TSS Bulletin

Date 06-21-2012, Issue 29

Purpose: Swingo 350B Recovery Tank Drain Plug Upgrade

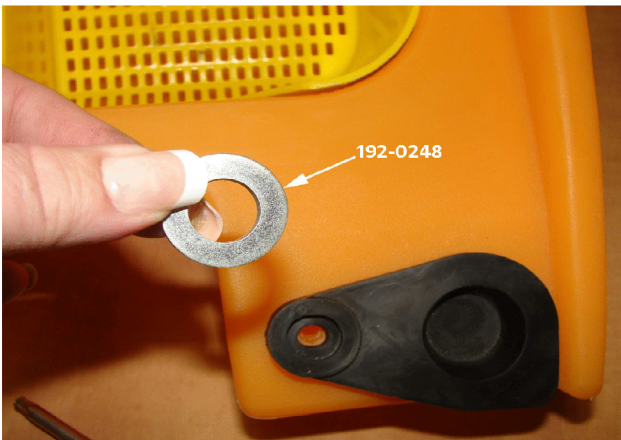
In some cases the drain plug has separated from the tank and affects recovery pickup performance. This update to the drain plug assembly will prevent this from happening.

Step 1: Remove the screw from the drain plug using a Torx T-30. Set screw aside as you will reuse it.

Step 2: Add the washer (part # 192-0248) to the drain plug.

Step 3: Replace the screw using the Torx T-30.
